ADDENDUM No. 1

RFP No. 26-12

Ingalls Kingsley Water Main Project

CITY OF ANN ARBOR - PUBLIC SERVICES - ENGINEERING
INGALLS KINGSLEY WATER MAIN
TYPICAL SECTIONS
E KINGSLEY ST - PROPOSED

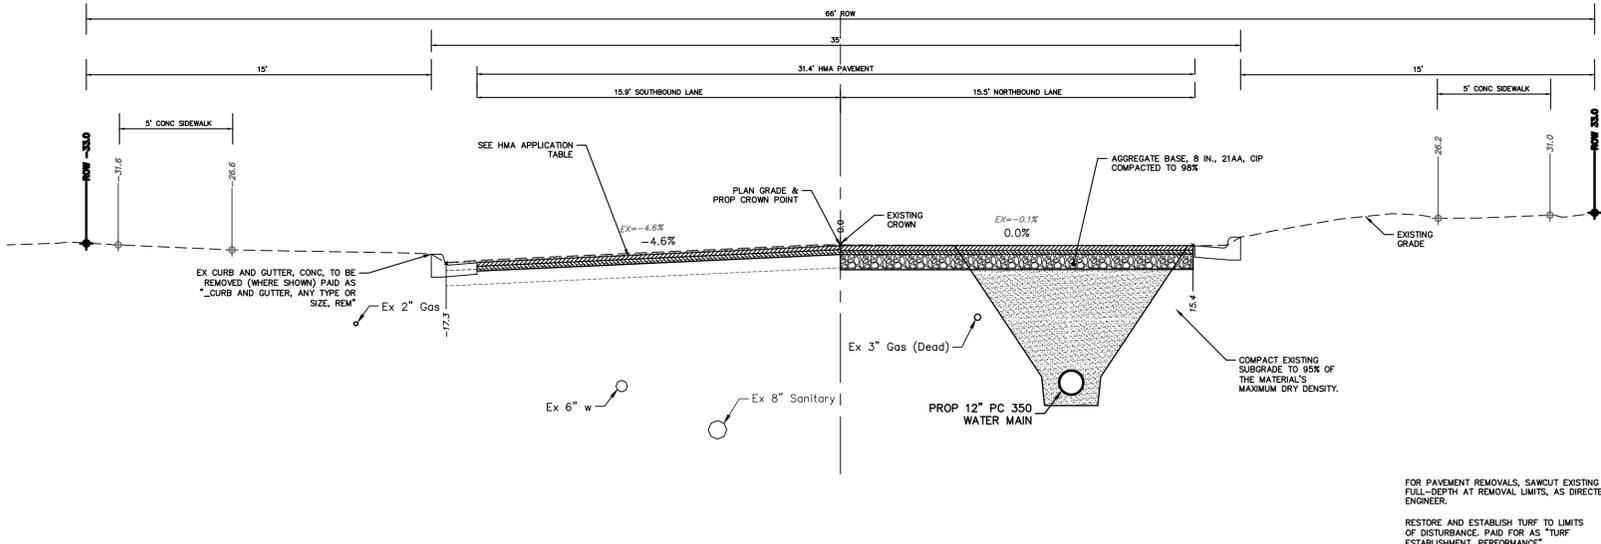
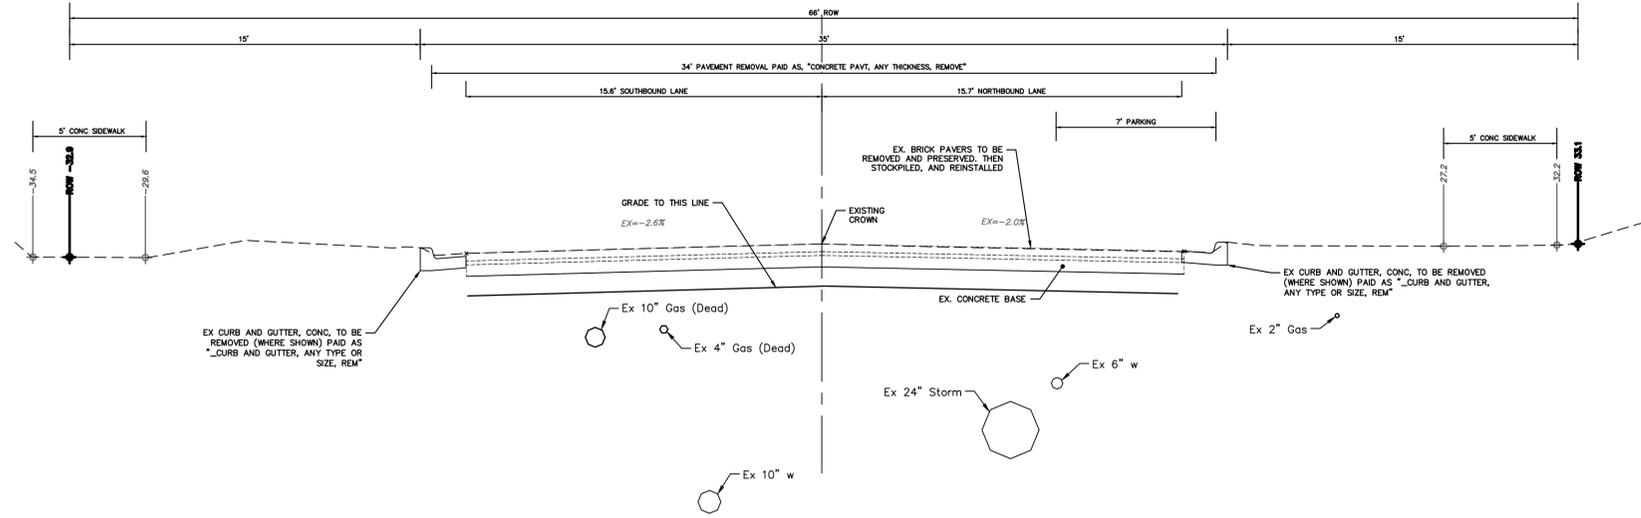
Section/Page(s)	Change
Schedule of Pricing / Cost	Schedule of Pricing/ Cost has been replaced in its entirety.
Plan Sheets 5 to 12	Plan sheets have been replaced in their entirety. Changes include: Revised cross sections. Extent of work is unchanged.

Question 11: The typical proposed cross sections show, Subbase 10 In, Class II, CIP. There is not a pay item in the proposal for Subbase 10 In, Class II, CIP. How is this item to be paid?

Question 13: Will some of the roads require the cross section as shown? I.e. The intersection of N. State Street.

Question 29: There is a discrepancy in the HMA pavement removal as shown from the plans vs. the pay items. In the plan cross section, it calls for Pavement Removal Paid as, "HMA Surface Remove." The only pay items are HMA, Any Thickness, Rem and Concrete Pat, Any thickness Removed. Should the profile be changed to Pavement Removal Paid as, "HMA, Any Thickness, Rem or Concrete Pavt, Any Thickness Removed?"

Answer 11: The sand subbase to be removed from the drawing, the revised cross sections are re-issued.

Answer 13: State Street will have brick sections, 22' x 30' HMA (like section shown) for water tie-in, and concrete for crosswalk.

Answer 29: Yes, the revised cross sections have been added.
